Mark Burns  
Environment/Remediation Manager, Services  
Level 14, Tower Three, International Towers Sydney  
Exchange Place, 300 Barangaroo Avenue  
Barangaroo NSW 2000  
14 September 2018

**Barangaroo, Stage 1B Perimeter Retention Wall, Hickson Road, Millers Point - modification of Stage 1B / 1C Crown section**

Figure 1

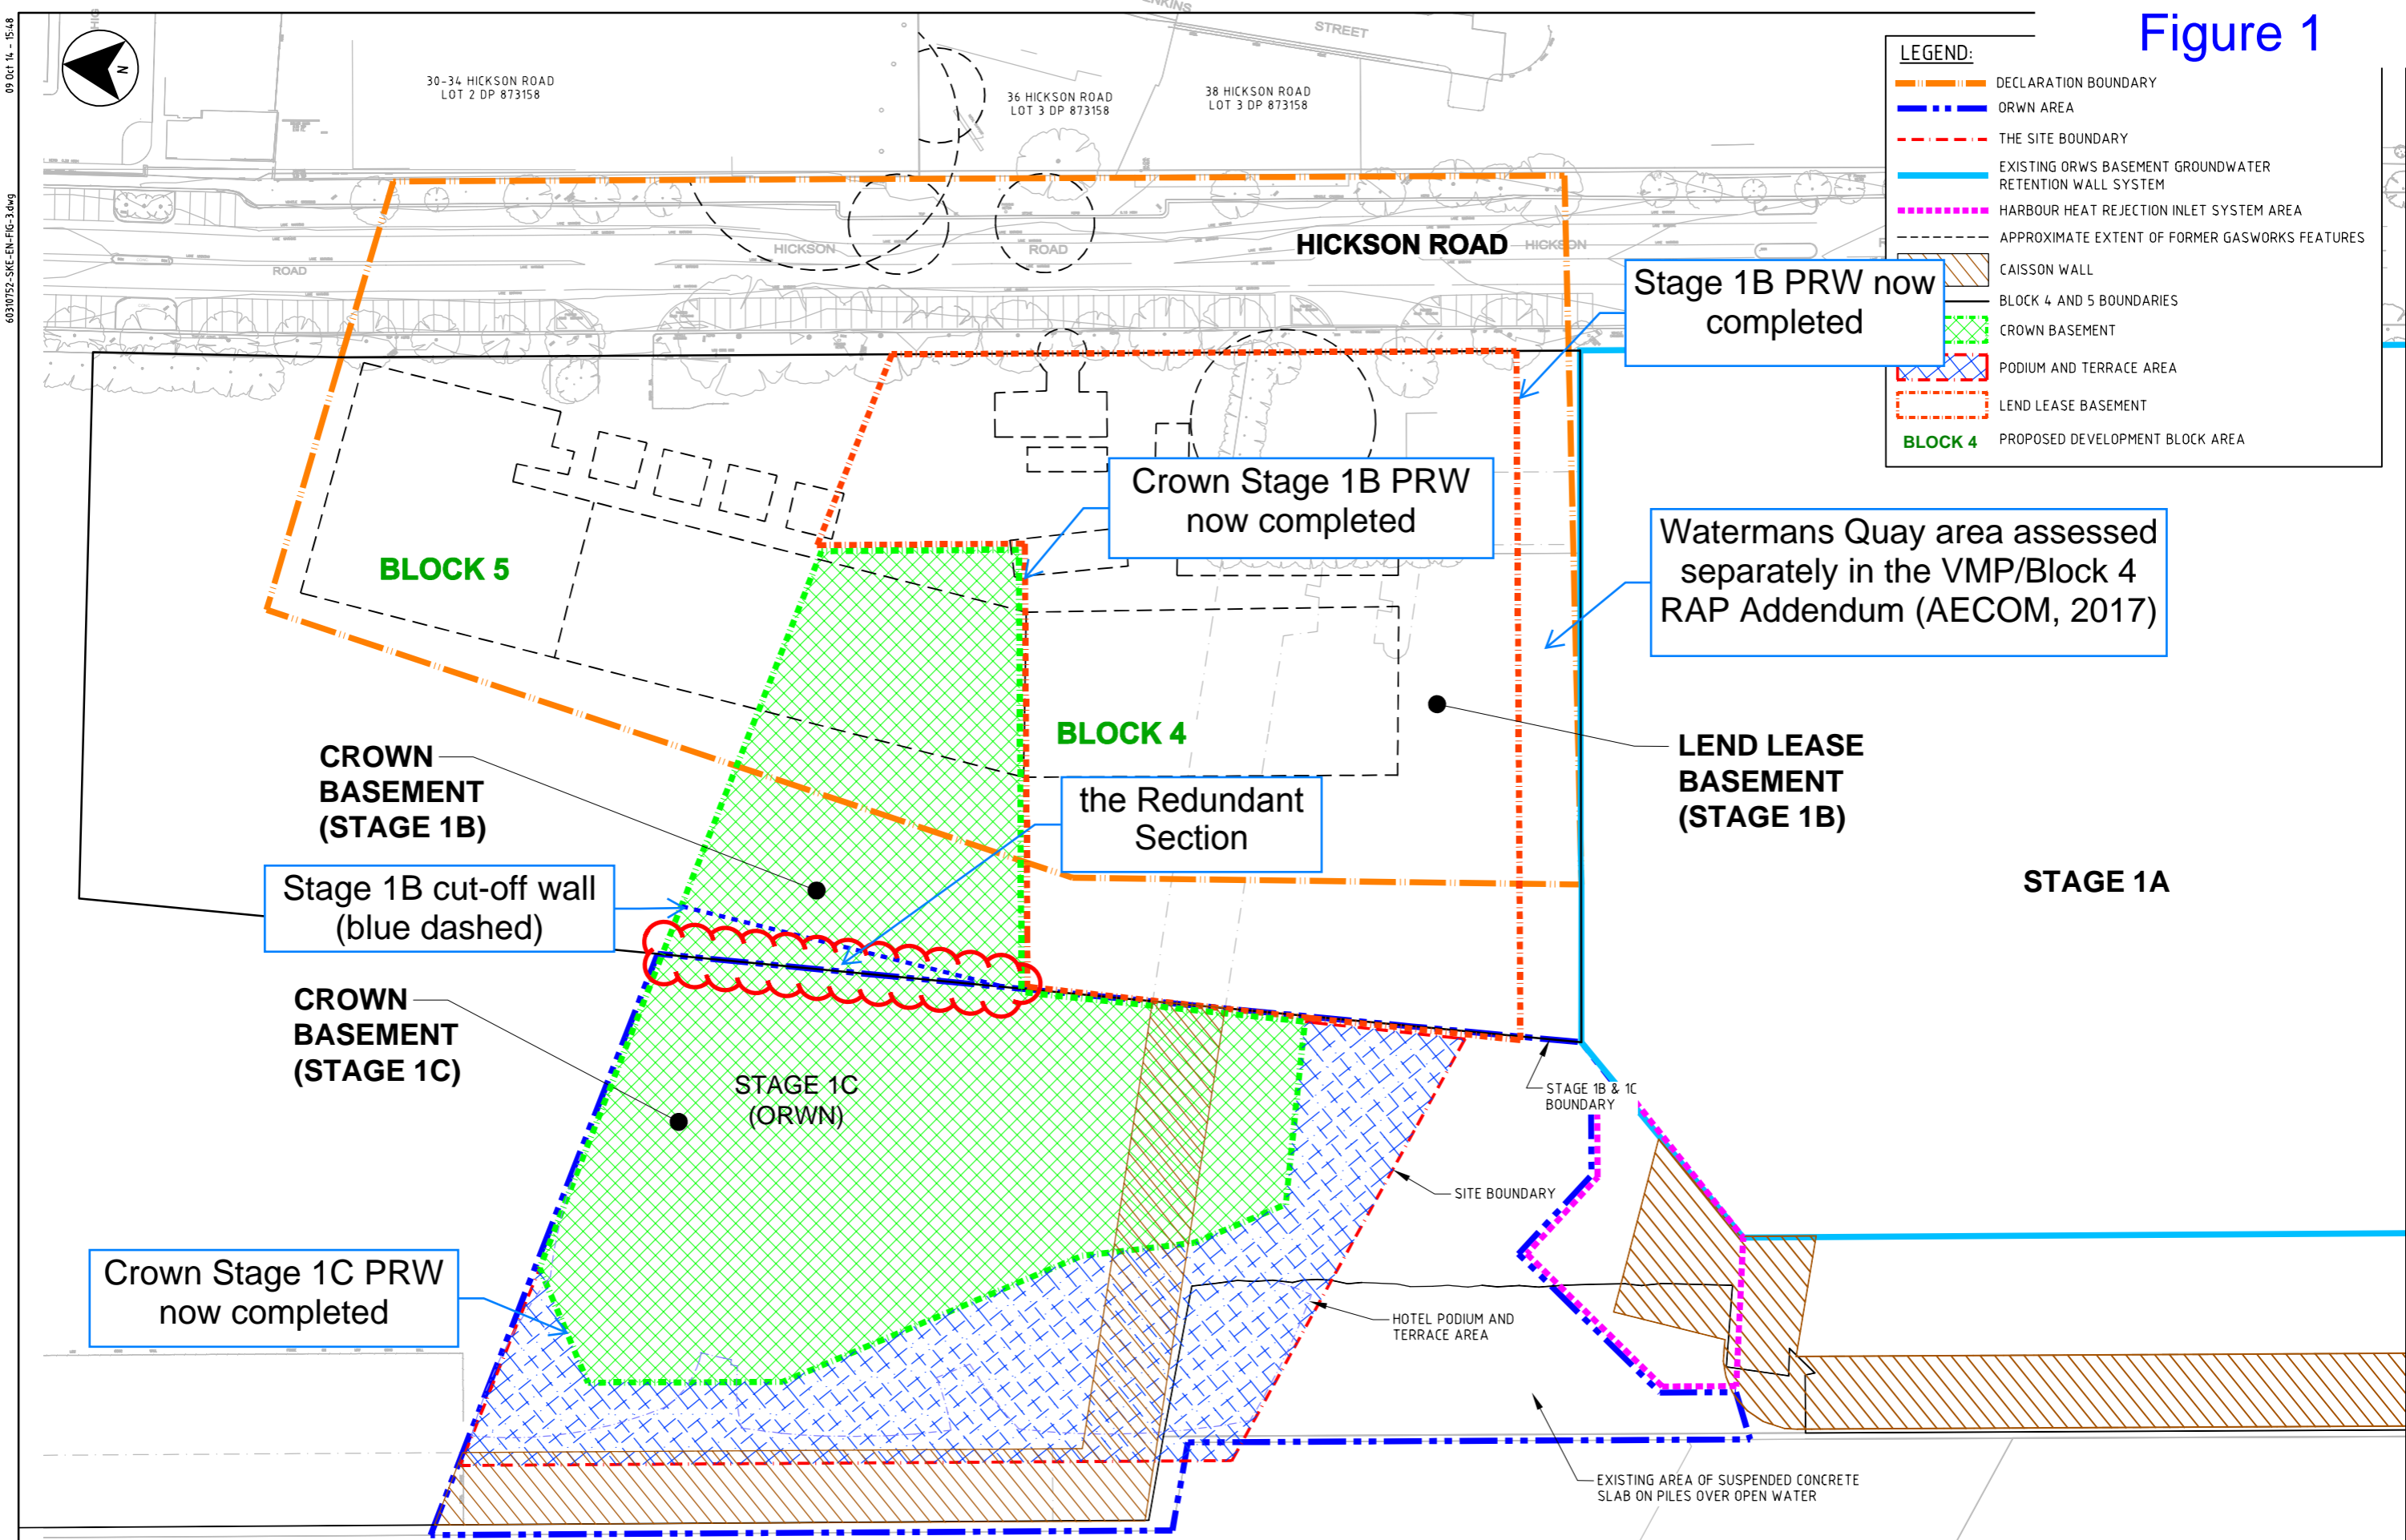
It is proposed that a section of the western Stage 1B PRW (hereafter referred to as the 'Redundant Section' will not be constructed (specifically, between the Crown Stage 1B and 1C basement areas) as shown on **Figure 1, Attachment 1**. This is because the basement proposed as part of the Crown Hotel Development will extend from the Stage 1C basement footprint into the northwest corner of the Stage 1B (Block 4) basement footprint (refer to the area shaded in green on **Figure 1, Attachment 1**)<sup>1</sup>. As a consequence, it will not be necessary to construct a PRW along that part of the Block 4 western boundary that will otherwise be within the Crown Basement (i.e. the 'Redundant Section').

It is considered that construction of the Stage 1C PRW (which is connected to the Stage 1B PRW), will effectively perform the same function as construction of the Redundant Section (refer to **Figure 1**). That is, it will minimise groundwater migration from Stage 1B to the nearest sensitive receptor Darling Harbour and, therefore, will comply with the requirements of the *VMP / Block 4 RAP* (AECOM, 2013) including the validation requirements of the Block 4 Development Remediation Works.

Consequently, it is considered that the Redundant Section of the PRW does not need to be installed to meet the requirements of the *VMP / Block 4 RAP* (AECOM, 2013).
